DEVELOPMENT NO.:	21015778
APPLICANT:	ProHealthCare Stirling – Janari Pty. Ltd.
ADDRESS:	104 MOUNT BARKER RD STIRLING SA 5152
NATURE OF DEVELOPMENT:	Alterations and additions to existing consulting rooms, removal of 1 regulated tree (<i>Eucalyptus maculate</i>), car parking and landscaping
ZONING INFORMATION:	<p>Zones:</p> <ul style="list-style-type: none"> • Rural Neighbourhood <p>Subzones:</p> <ul style="list-style-type: none"> • Adelaide Hills <p>Overlays:</p> <ul style="list-style-type: none"> • Hazards (Bushfire - Medium Risk) • Mount Lofty Ranges Water Supply Catchment (Area 2) • Native Vegetation • Prescribed Water Resources Area • Regulated and Significant Tree • Traffic Generating Development • Urban Transport Routes <p>Technical Numeric Variations (TNVs):</p> <ul style="list-style-type: none"> • Minimum Site Area
LODGEMENT DATE:	29 Jul 2021
RELEVANT AUTHORITY:	Assessment panel at Adelaide Hills Council

PLANNING & DESIGN CODE VERSION:	Version 2021.10 - (29 July to 11 August 2021).
CATEGORY OF DEVELOPMENT:	Code Assessed - Performance Assessed
NOTIFICATION:	Yes
RECOMMENDING OFFICER:	Aaron Wilksch (Consultant Planner) for Melanie Scott, Senior Statutory Planner
REFERRALS STAT

Figure 2 - Application plans prepared by Architects Ink identifying trees to be removed.

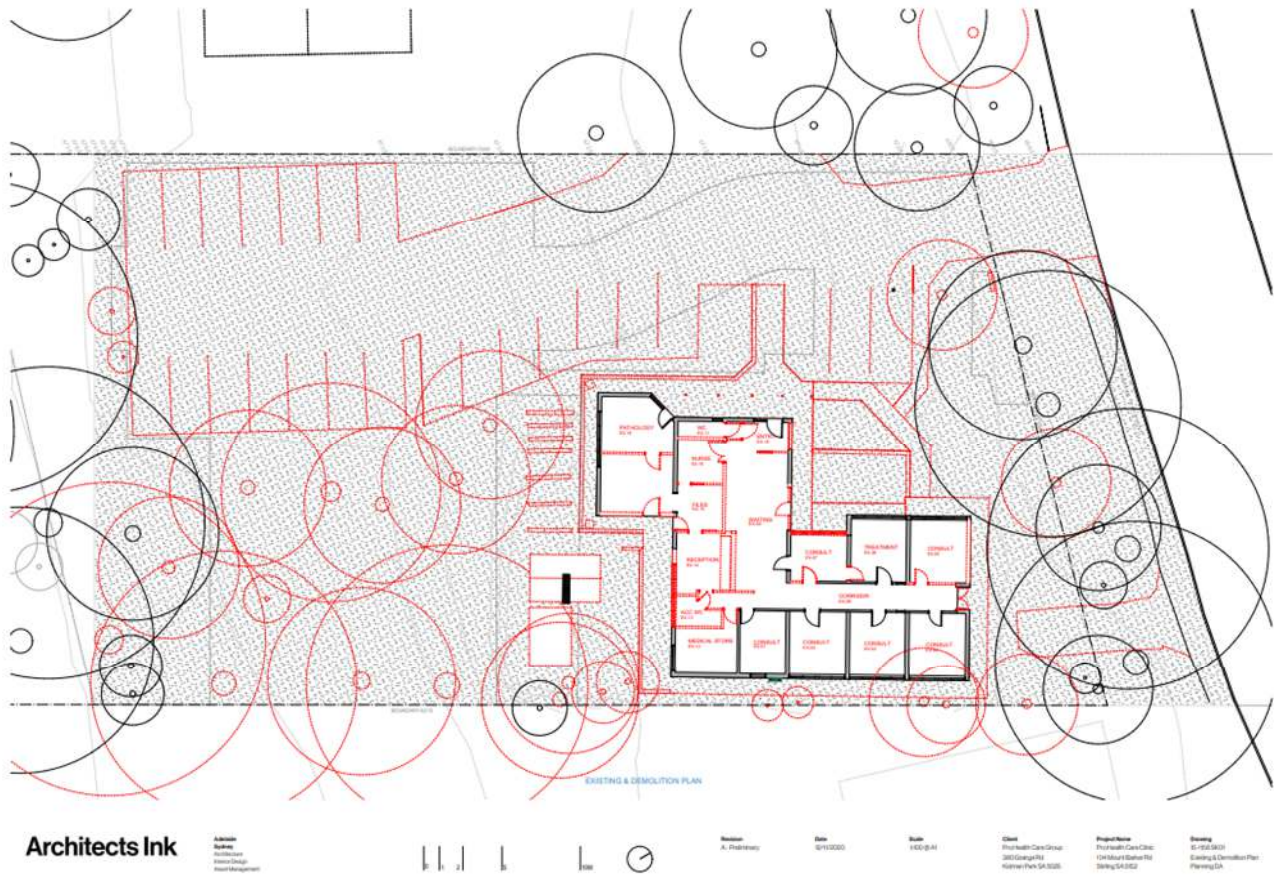
The trees being removed were identified in the application plans prepared by Architects Ink dated 12/11/2020 (Figure 2) and landscaping plan prepared by Bruce Oswald Landscape Architect, 23 November 2021, (Figure 3) provided as part of the assessment documents to the February 2022 Assessment Panel meeting.

Figure 3 - landscaping plan prepared by Bruce Oswald Landscape Architect identifying tree species and trunk diameters.

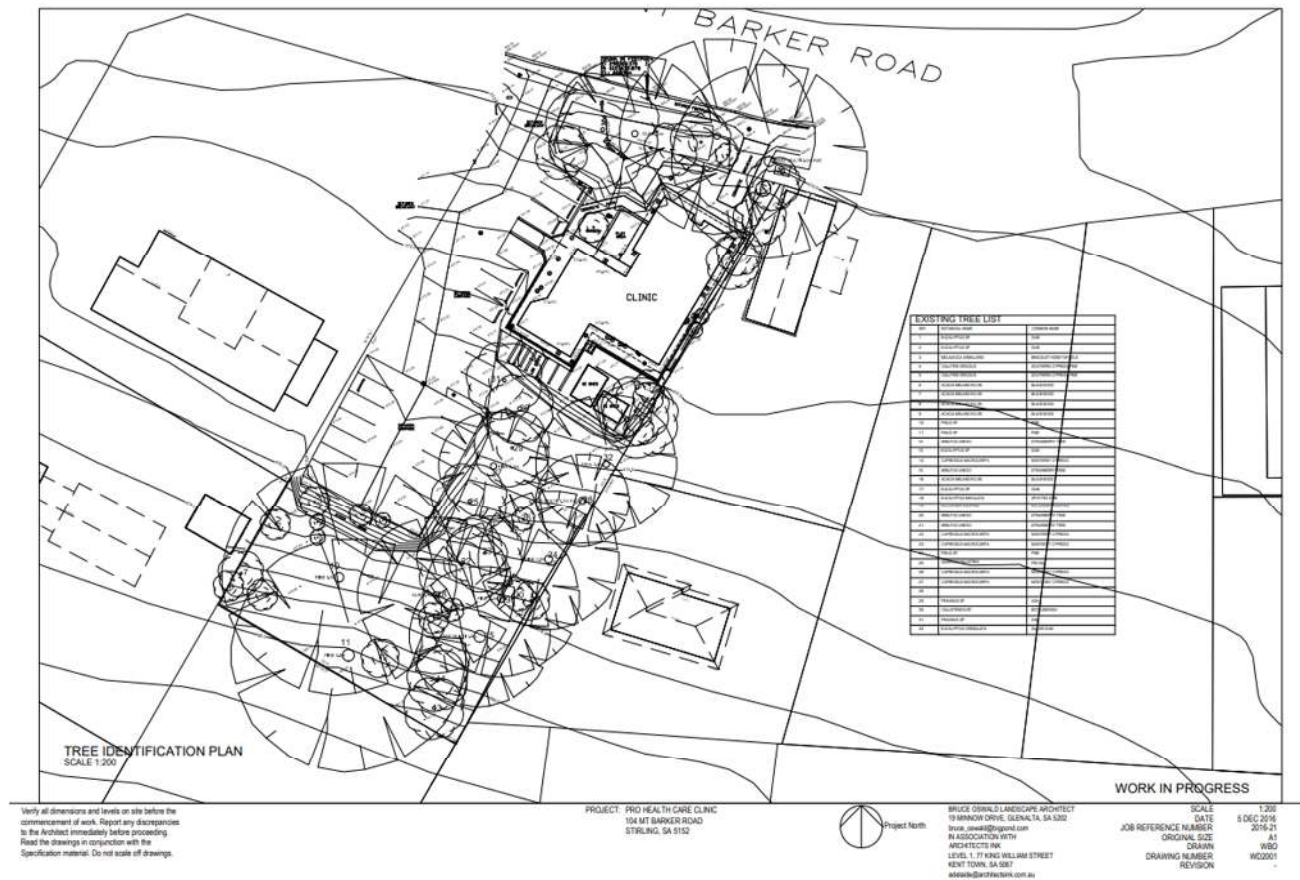
The trees and species (taken from the above two plans) to be removed are identified as:
